Minor Amendment to DRB Approved Site Plan (Project #1003993) located at 3421 Coors Blvd. NW - to add overflow parking area + assoc. flatwork

Letter of Justification

Sobremesa Restaurant & Brewery – 3421 Coors Blvd. NW – Site Improvements – Administrative Amendments

1 SITE PLAN - SITE MODIFICATIONS
1/16" = 1'-0"

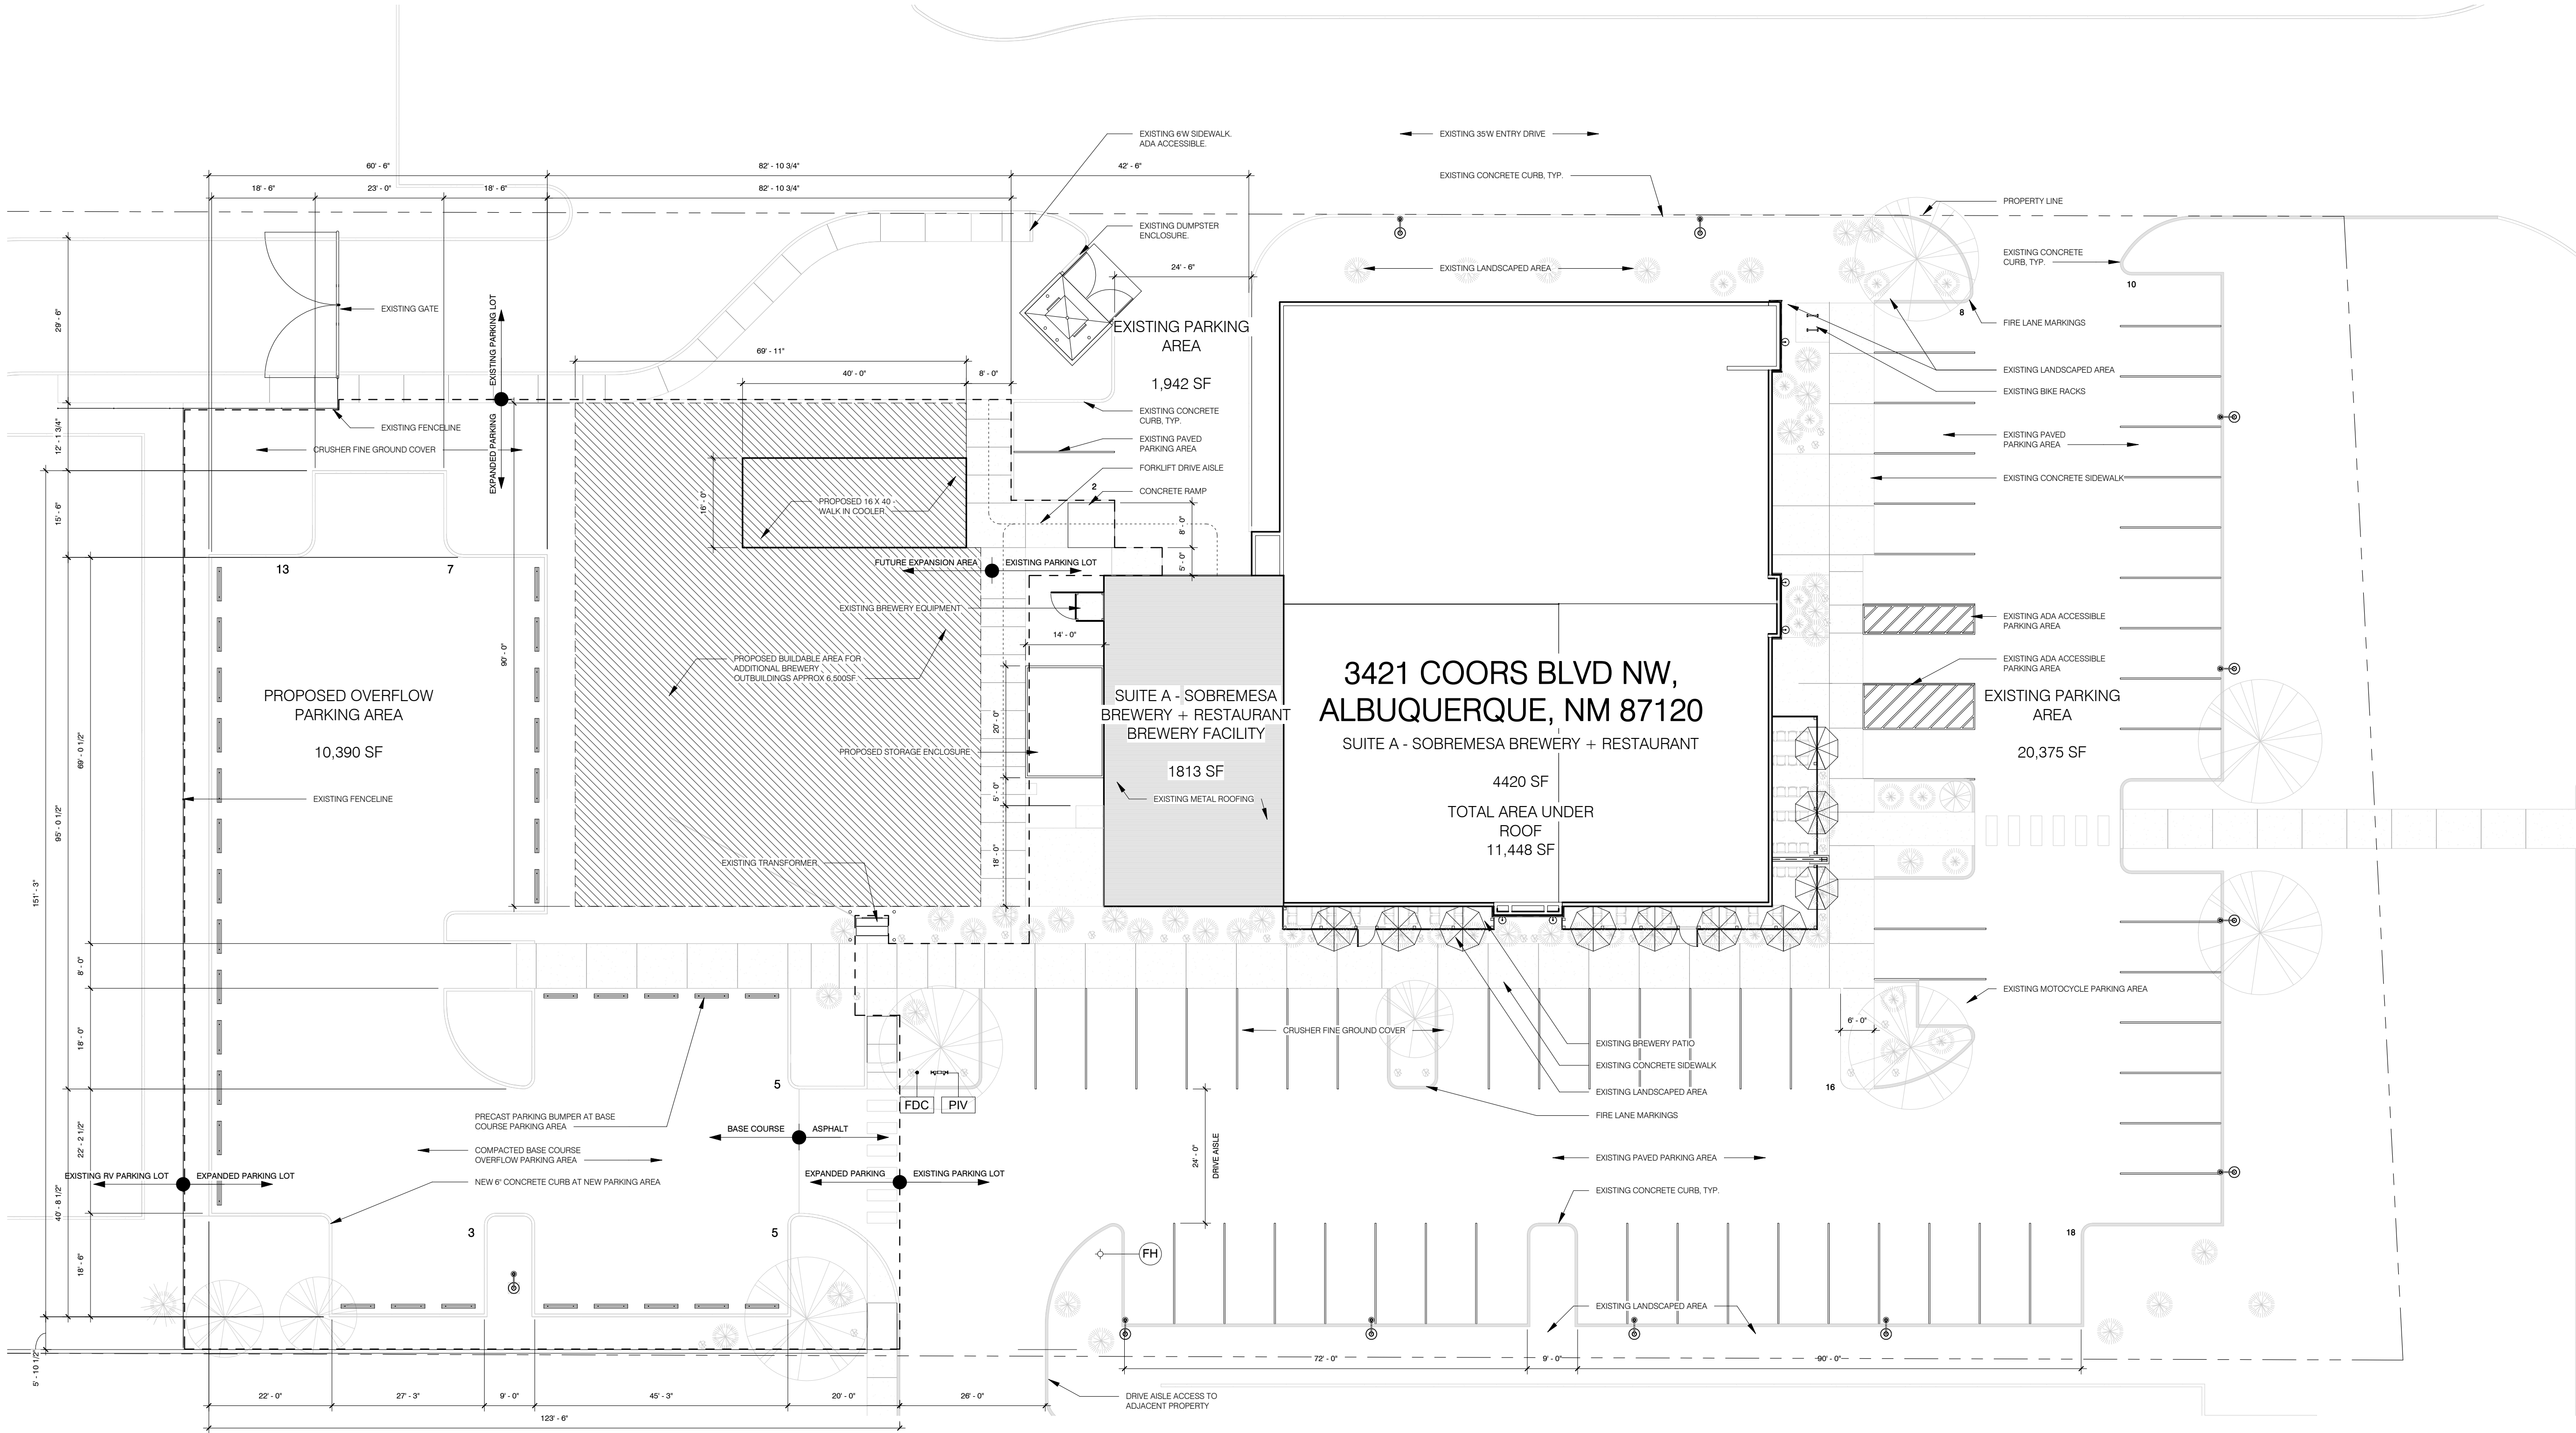
The attached revisions to the DRB approved Site Development Plan at 3421 Coors Blvd. NW being submitted for your review and administrative approval. The following revisions are being requested and are depicted on the attached Proposed Site Plan Improvements (Sheet AS101):

- New 10,300 SF overflow parking area of compacted crusher fines west of existing Brewery + Restaurant building.
 - Includes parking bumpers, curbs, pedestrian walkways, and dark skies compliant parking lot pole mounted lighting (to match lighting already installed elsewhere on site)
 - New crosswalk and curb work at revised pedestrian crossing
 - Parking lot shall comprise 32 additional parking spaces
- Approx 8,000 SF undeveloped area for future development of site (not in scope of Administrative Amendment)
 - New 8'-0" Concrete walkway for future expansion
 - Revised curb work at two (2) west parking spaces
